UNITED STATES
NUCLEAR REGULATORY COMMISSION
WASHINGTON, D. C. 20555

SAN ONOFRE NUCLEAR GENERATING STATION UNIT NO. 1

AMENDMENT TO PROVISIONAL OPERATING LICENSE

Amendment No. 55
License No. DPR-13

Figure 2.1.1
Safety Limits
Temperature, Power, Pressure
RCS Flow \geq 195,000 GPM

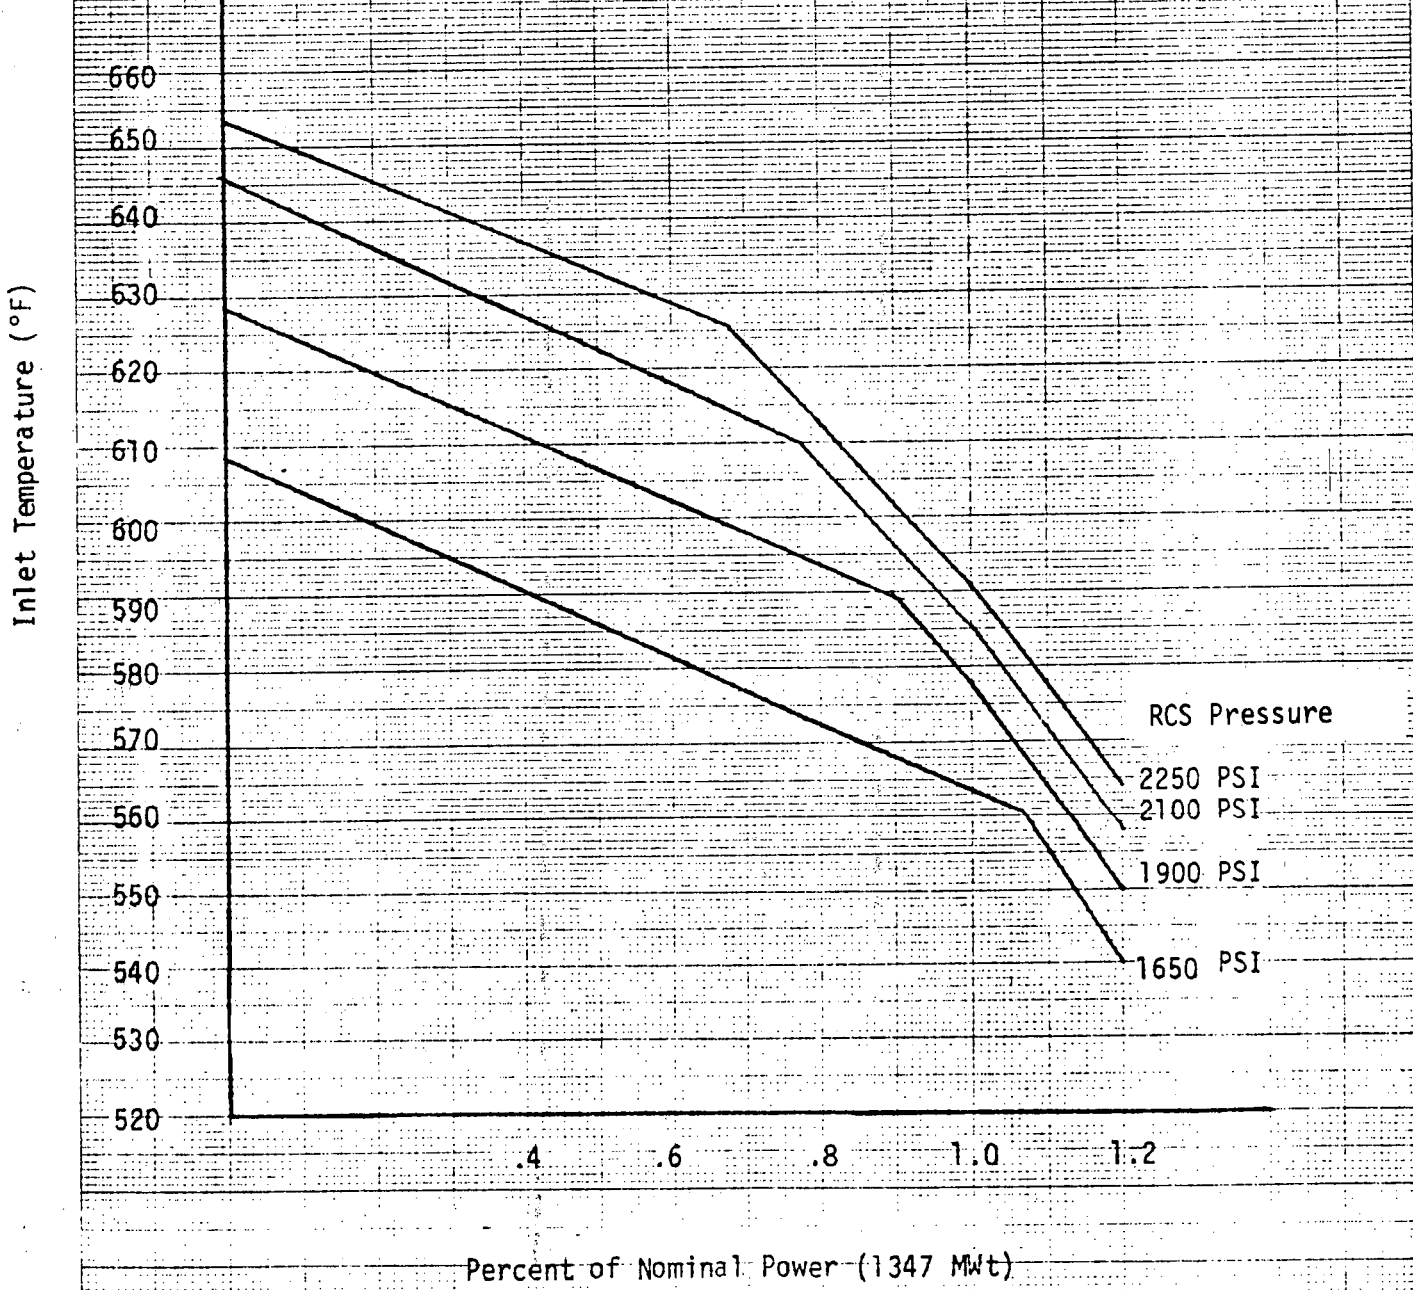
- (1) The reactor coolant system pressure shall not exceed 2735 psig with fuel assemblies in the reactor.
- (2) The combination of reactor power and coolant temperature shall not exceed the locus of points established for the RCS pressure in Figure 2.1.1. If the actual power and temperature is above the locus of points for the appropriate RCS pressure, the safety limit is exceeded.
